Proposed Revisions to a Standard Plans Index

Index Number: 509-070

Railroad Grade Crossing Traffic Control Devices

Summary of the changes:

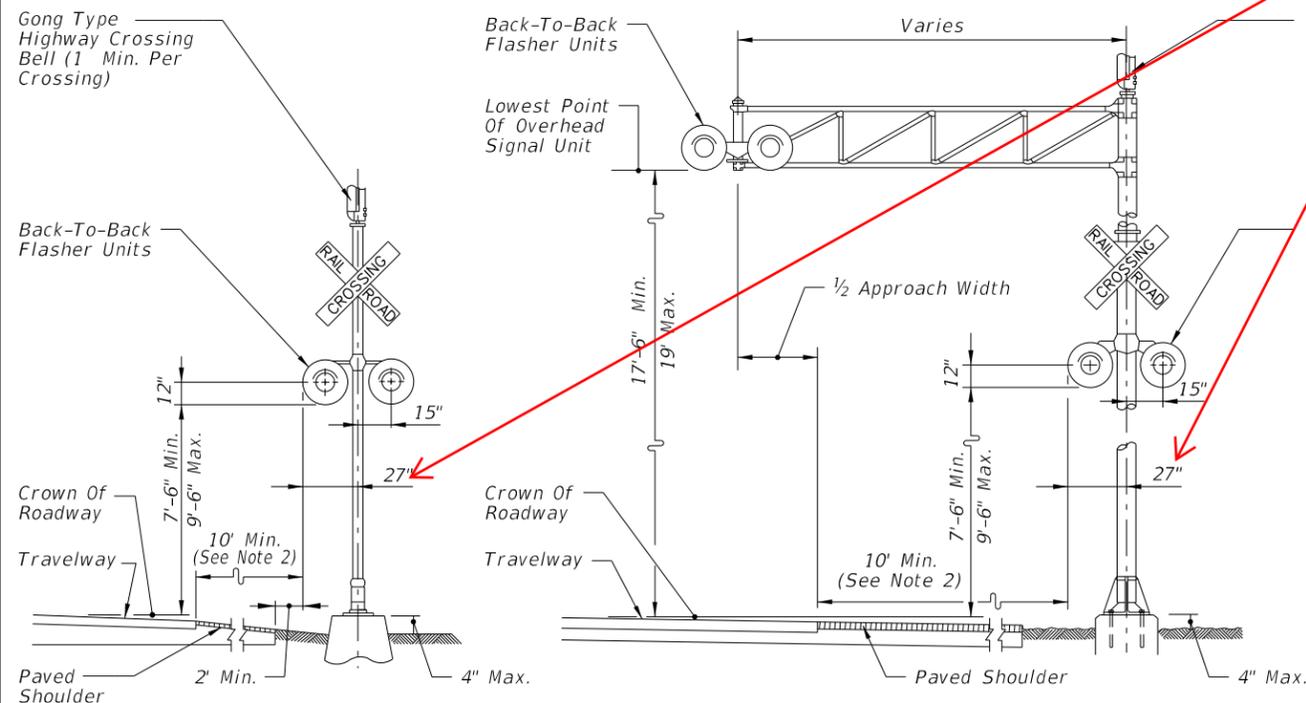
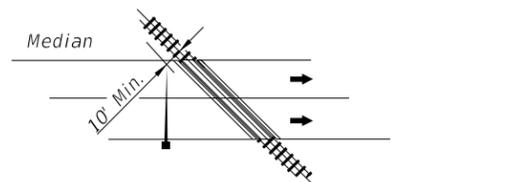
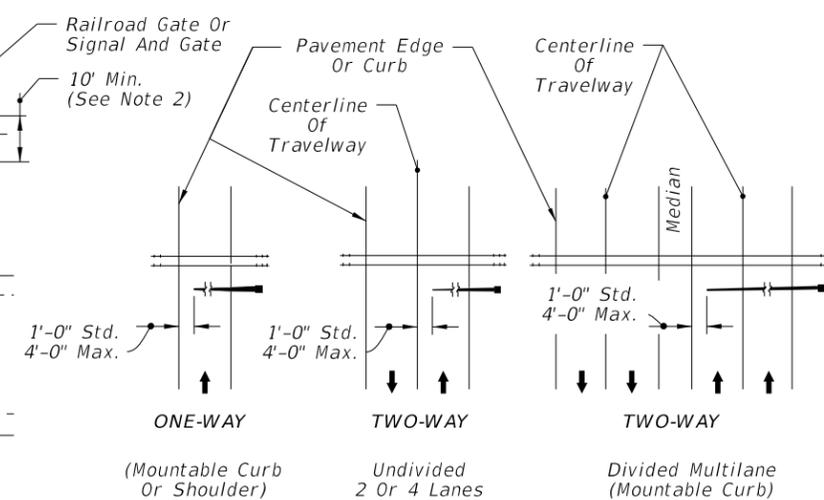
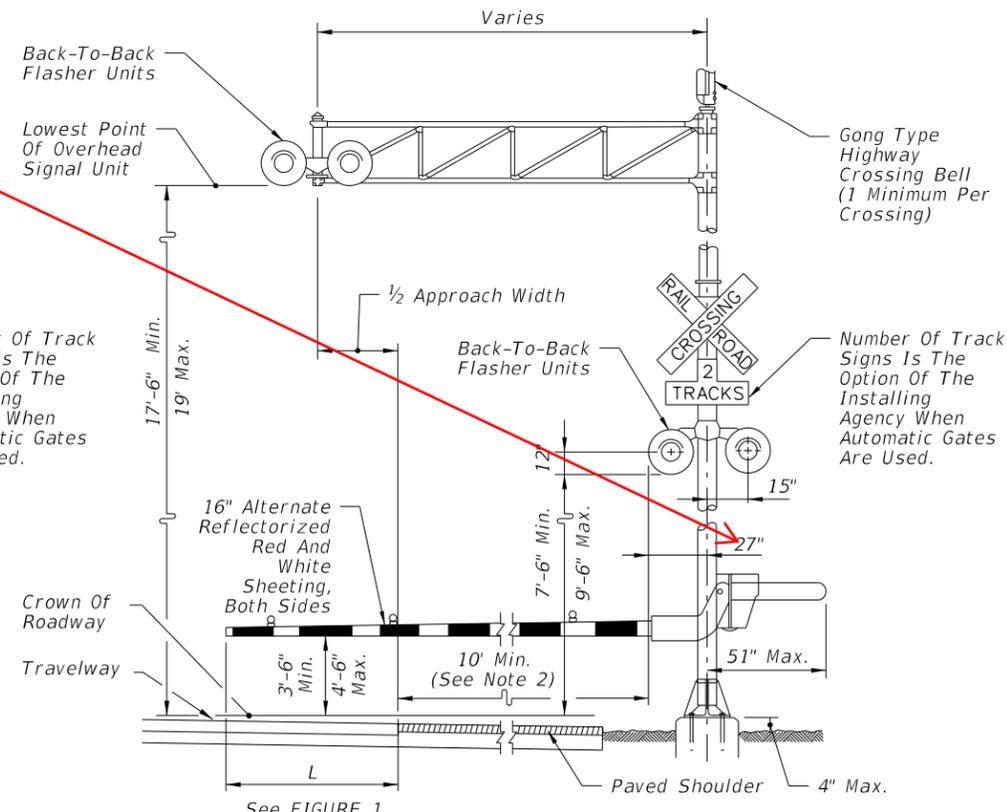
Sheet 1: Change General Note 5 , Class VI to 3-4; Delete Type V and Type VI from Traffic Control Devices for Flush Shoulder Roadway Details: Added "Std." to the 27" dimension in Type I through Type V.

CHANGED TO: 3-4 →

TYPE III AND TYPE V ← **DELETED**

TYPE IV AND TYPE VI ← **DELETED**

ADDED: Std.

LAST REVISION 02/05/21	REVISION 11/01/23	DESCRIPTION:		FY 2023-24 STANDARD PLANS	RAILROAD GRADE CROSSING TRAFFIC CONTROL DEVICES	INDEX 509-070	SHEET 2 of 3
---------------------------	----------------------	--------------	--	------------------------------	--	------------------	-----------------

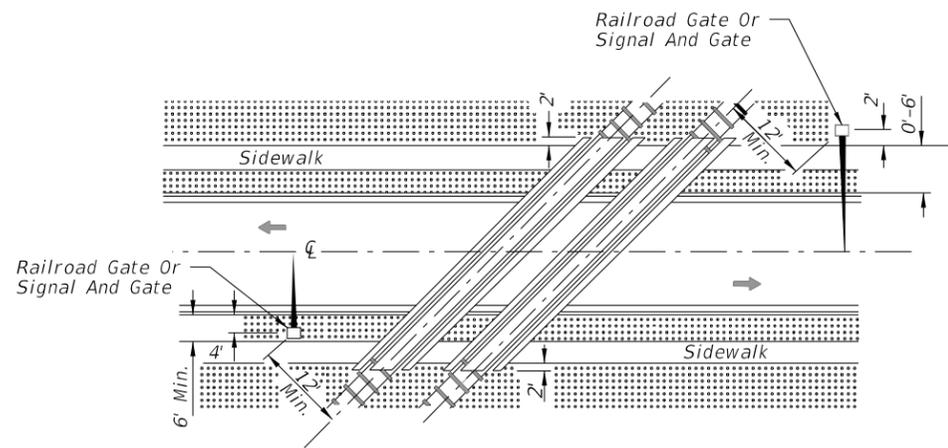
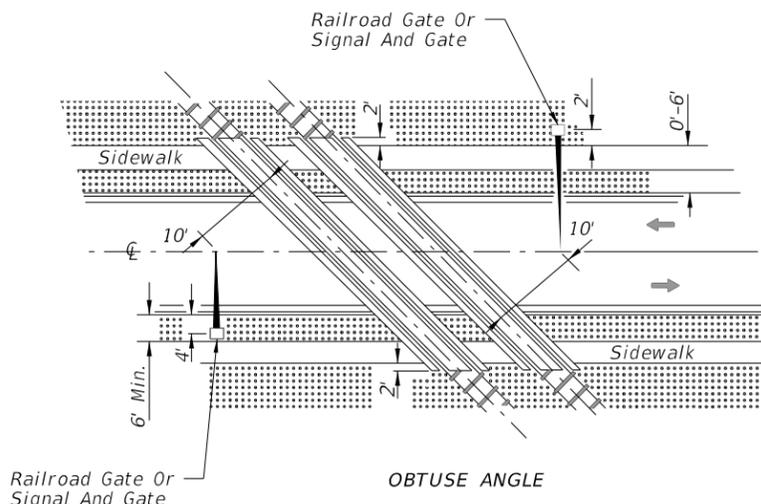
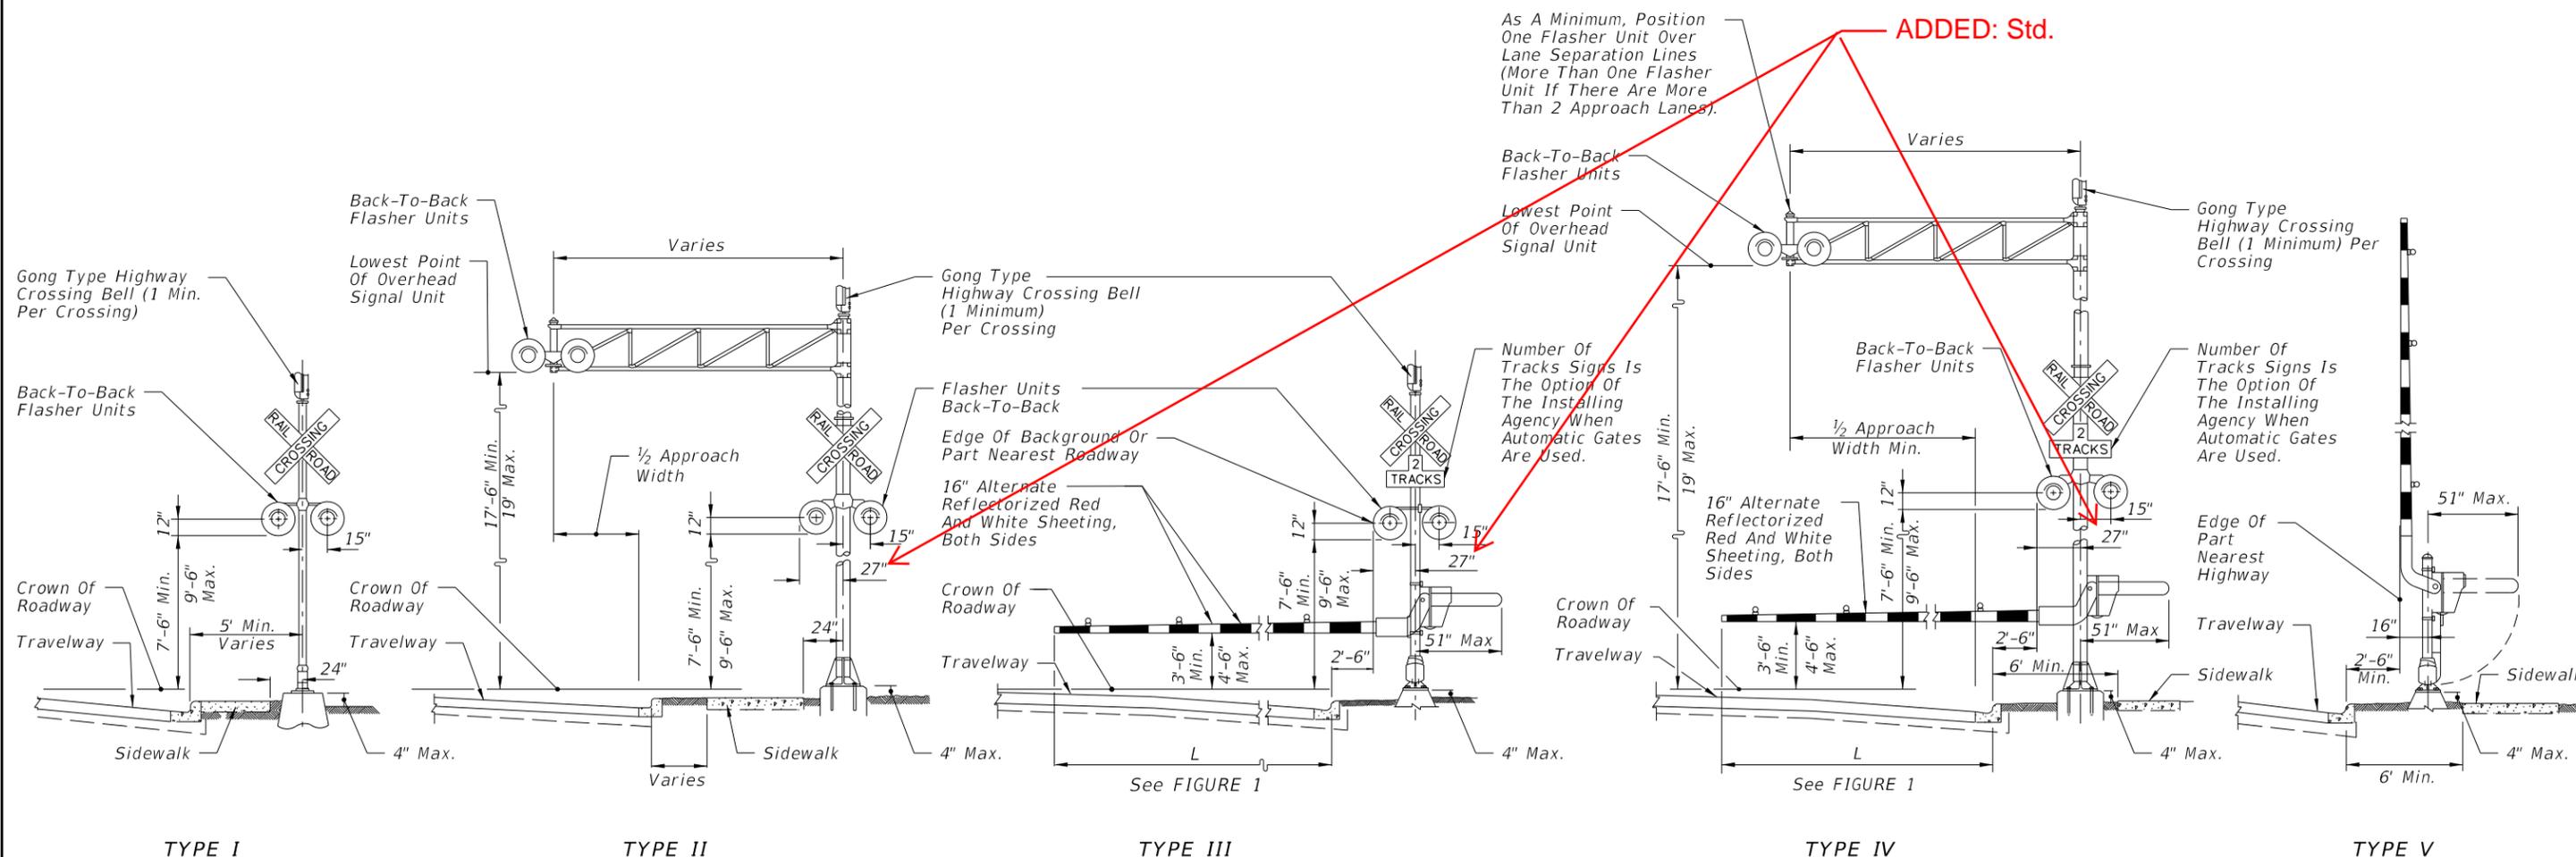
Sheet 2: Added "Std." to the 27" dimension in Type II through Type IV.

PLAN

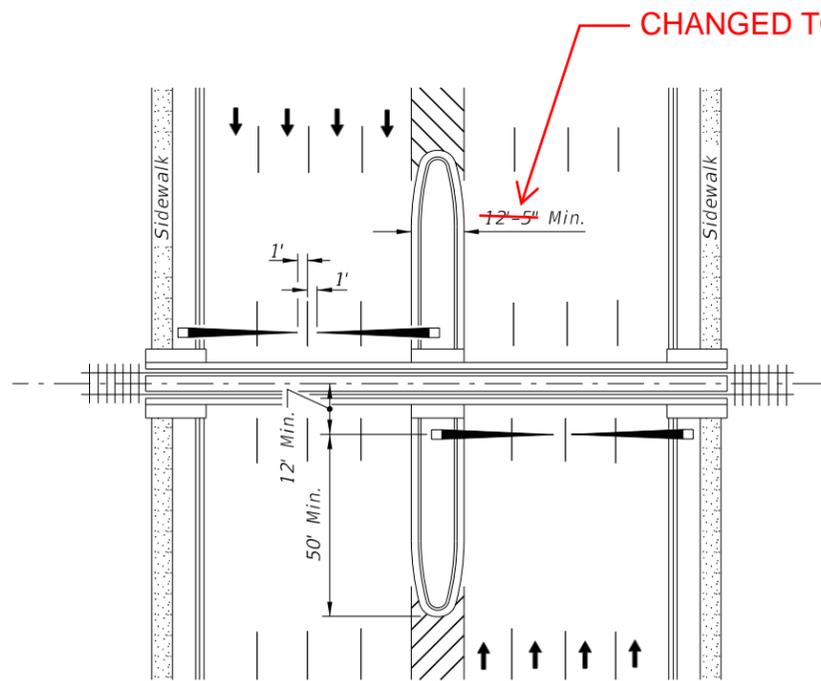
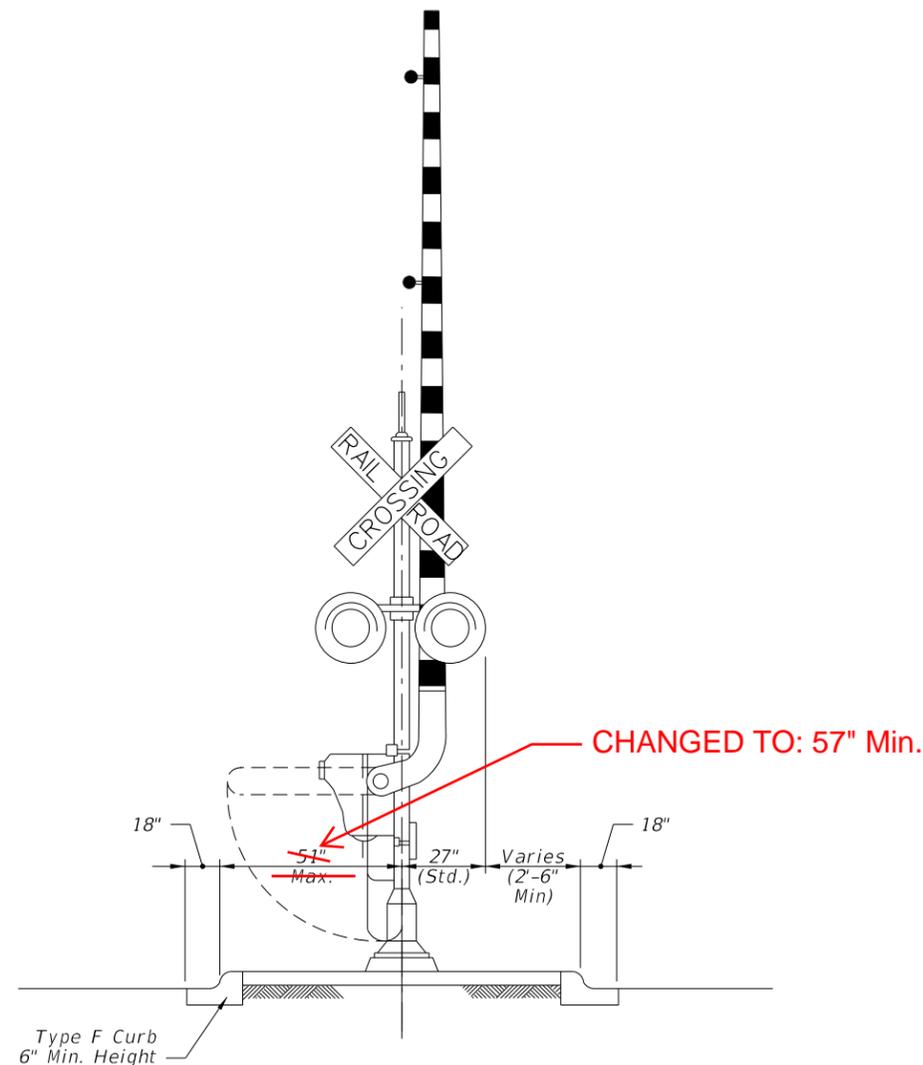
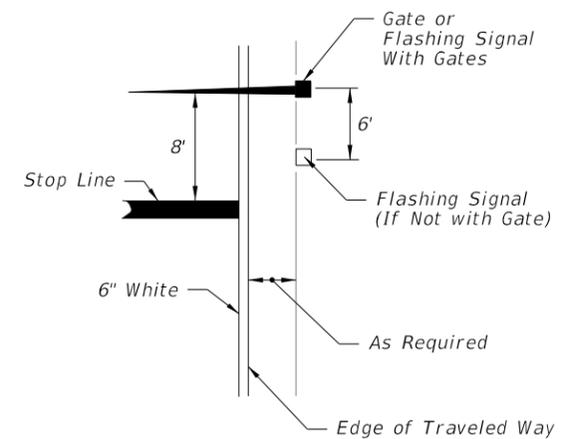
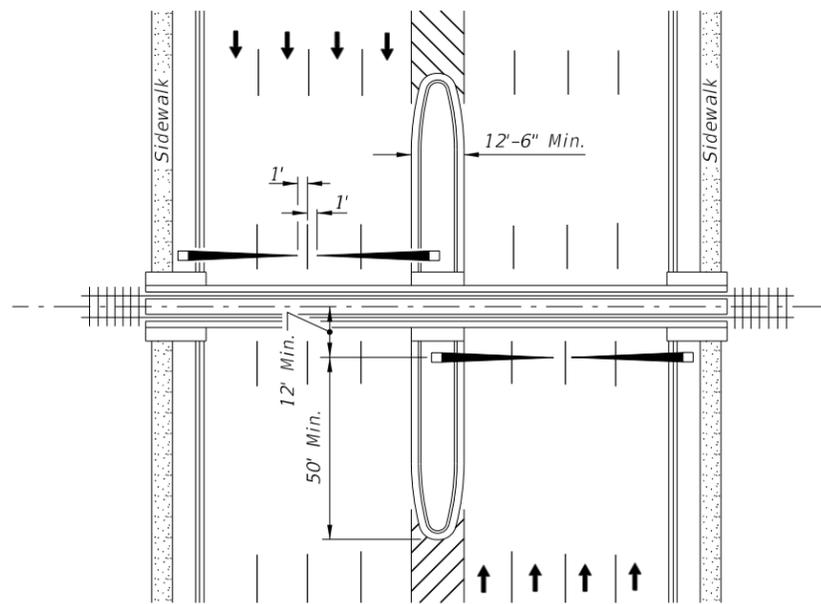
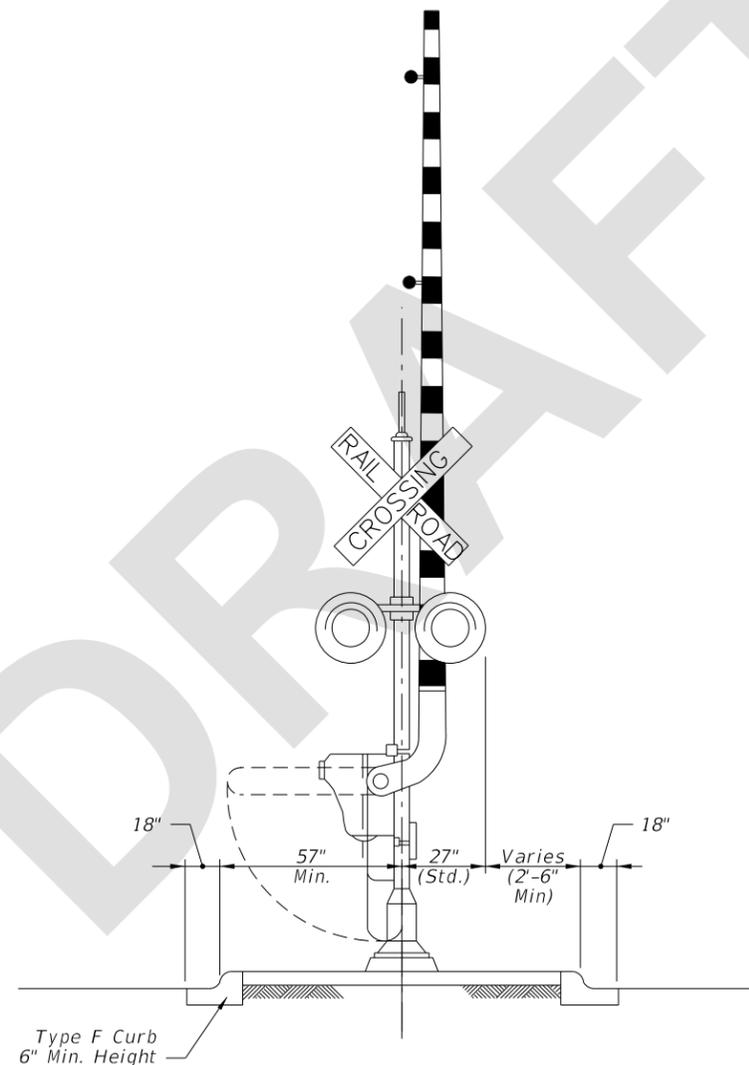
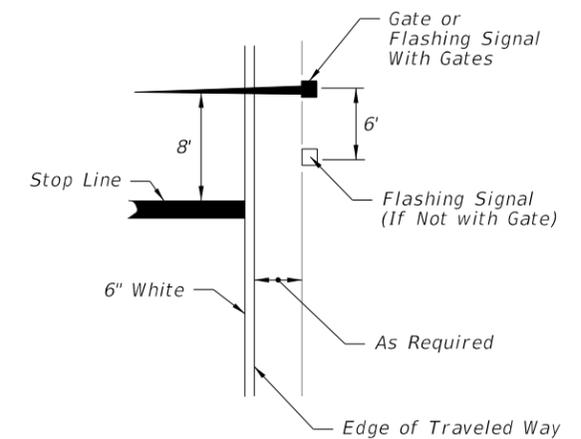
Sheet 3: Change 12'-5" min to 12'-6" Min. in PLAN; Change 51" Max to 57" Min in Median Section at Signal Gates Detail.
